**From:** "ZINKE, GEORGE A" <GZINKE@entergy.com>  
**To:** "Christian J Araguas (cja2@nrc.gov)" <cja2@nrc.gov>, "Mark Blumberg" <wmb1@nrc.gov>, "Bret Tegler" <bat1@nrc.gov>, "kazimieras campe" <dcampe@verizon.net>, "Lynn Mrowca" <lxm4@nrc.gov>, "Margie Kotzalas" <mxk5@nrc.gov>  
**Date:** Wed, Mar 1, 2006 1:09 PM  
**Subject:** GGNS ESP BARGE HAZARD SUPPLEMENTAL INFORMATION

### Supplemental Information: Grand Gulf Early Site Permit, SSAR Section 2.2, Nearby Industrial, Military and Transportation Facilities and Routes

#### NRC Staff Clarification Questions

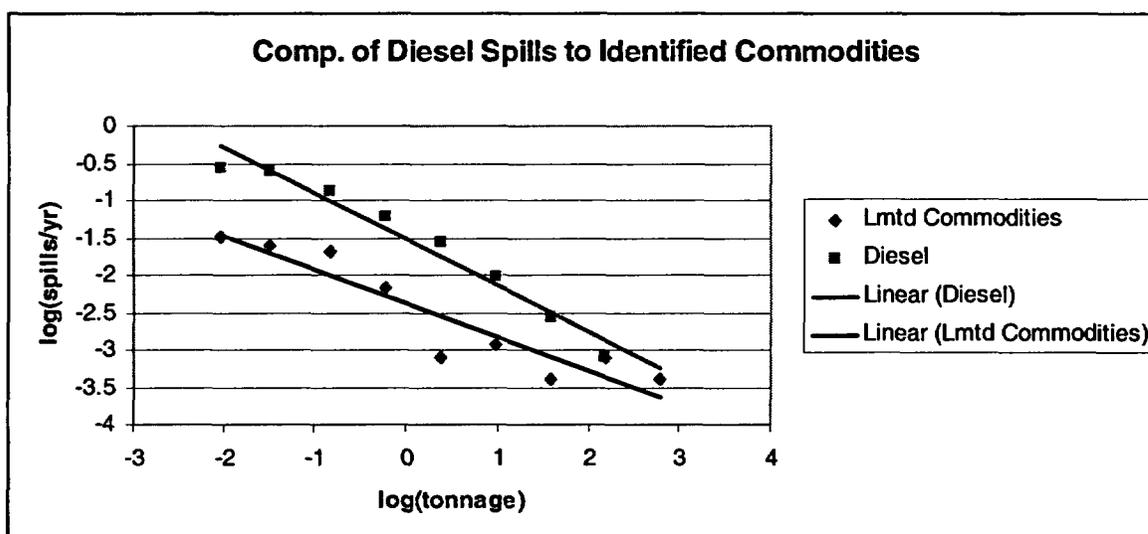
**4. Page 22, 2.1 Spill Frequency Assessment: What is the basis for excluding spills involving commodities such as chlorine, coconut oil, diesel, lubricating oil ,etc? It is reasonable to expect a spill being the result of some sort of loss of tankage integrity (e.g., puncture, rupture). Hence, there is no apparent functional relationship between the type of commodity and the initiation of a spill in the event of a barge mishap. Exclusion of spills on the basis of commodity type can lead to a significant underestimating of the spill frequency.**

As an example, consider the spill frequency versus tonnage relationship developed

in the RAI Response text (Section H). If the total number of spills in each bin is ten times greater, then the curve fit will be an order of magnitude greater ( $f = 10 \cdot 10^{0.4871 \cdot \text{LOG}(\text{tonnage}) - 2.7457}$ ). But then, when determining the fraction of spills that are one of the critical commodities, a multiplication factor of 1/10 would be applied, providing the same equation,  $f = 10^{(-0.4871 \cdot \text{LOG}(\text{tonnage}) - 2.7457)}$  again.

Of course, the new spills may not increase each bin total by an identical ratio. If the new spills tended to be of a smaller size, they would tilt the curve fit such that it would have a more negative slope. Evaluation of diesel spills (all spills in the MislVslPoll database identified as diesel, some 2102 spills), show this is the case. A plot of curve fits to diesel spills and to the commodities previously identified is shown below. Since the diesel curve fit is steeper, it would be non-conservative to include diesel spills.
